28 - 42 PACIFIC HIGHWAY, ST LEONARDS (LOT 1 DP 746012, LOT A AND LOT B DP 418201 AND LOT D 419240)

DEVELOPMENT APPLICATION NO: DA 97/2025 (PAN-563091)

RESPONSE TO LANE COVE COUNCIL REQUESTS FOR ADDITIONAL INFORMATION

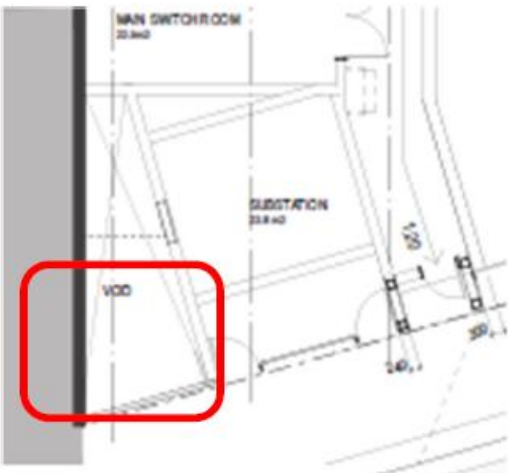
Marshall Lane - Retail Access <i>Council requires more information regarding pedestrian access into the LG retail space from Marshall Lane. Council does not support pedestrian access currently via trafficable lane, no footpath is shown in the plan provided. Applicant to consider paving/shared-way improvement to Marshall Lane.</i>	The Applicant acknowledges Council’s concern regarding pedestrian safety and access to the lower ground (LG) retail tenancy from Marshall Lane. It is noted that Marshall Lane presently functions as a trafficable service lane with limited pedestrian infrastructure. The submitted plans did not indicate a dedicated pedestrian footpath due to existing site constraints and the current lane configuration. In response to Council’s comments, the Applicant is prepared to investigate opportunities to enhance pedestrian access, safety and legibility, in collaboration with Council noting that these

Item	Response
	works would be within the public domain adjoining the site outside the boundaries of the subject site.
Marshall Lane – Void / Potential Deep Soil Ground Planting Zone <i>The applicant shall provide a tree (Livistona australis - min 6m H) in ground garden bed in the setback along Marshall Lane adjacent to the proposed void and substation. Applicant to consider and advise suitability of on structure planting bed in the proposed void at the same level.</i> 	The void is required for air supply to plantroom below.
Marshall Lane – Paving / Frontage <i>Please advise paving treatment to lower ground setback and transition to Marshall Lane. The Marshall Lane render (Architectural Drawing A-901) appears to be a misrepresentation of the frontage, inconsistent with the lower ground floor plans – the render shows a footpath and existing tree retained.</i>	This is correct. We can amend the perspective, if required. No pavement within boundary.

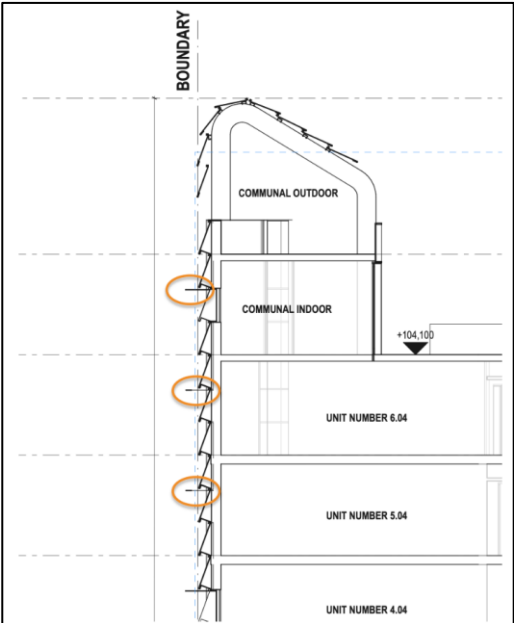
Item	Response
<i>encroach into the road reserve. In this regard, TfNSW does not support any new buildings or structures (other than pedestrian footpath awnings) being located in/overhanging the road reserve of Pacific Highway (unlimited in height or depth) and would not issue concurrence under section 138 of the Roads Act 1993 to these structures. The plans should be amended to rectify this and ensure these components are located within the freehold property boundary, to the satisfaction of Council as the relevant planning authority.</i>	Transport Planning) and aiming to have a formal direction on this matter in-line with the commentary below. It is clarified that the elements referred to as 'louvres' are in fact minor light-weight horizontal awnings designed to provide weather protection and architectural articulation to the building façade. These are not structural building elements or enclosed projections. If the blades were required to be deleted, this would increase the reliance of mechanical cooling and reduce the environmental performance of the building. The louvered façade is wholly contained within the property boundaries - refer to below:  The minor protrusions are comparable to footpath awnings, which are a permissible and typical streetscape feature along the Pacific Highway (including the existing footpath awnings that currently exist along the frontage of the site) and supported by TfNSW in similar urban contexts. Furthermore, volumetrically there will be less projections into the SP2 zoned land as a result of the proposed hotel than the existing condition given the removal of the existing awnings – refer to

Item	Response
	below:  Requiring these architectural elements to be set back would necessitate a 450mm setback of the entire façade, which would in turn: • Compromise the design integrity of the building, • Create an incongruous streetscape outcome once adjoining developments are constructed to the boundary, and • Diminish the intended weather protection and passive design benefits of the awnings. Accordingly, it is respectfully requested that TfNSW reconsider its position, noting that the proposed awnings do not result in any material obstruction or structural occupation of the road reserve and would not prejudice road safety or future infrastructure along the Pacific Highway frontage.
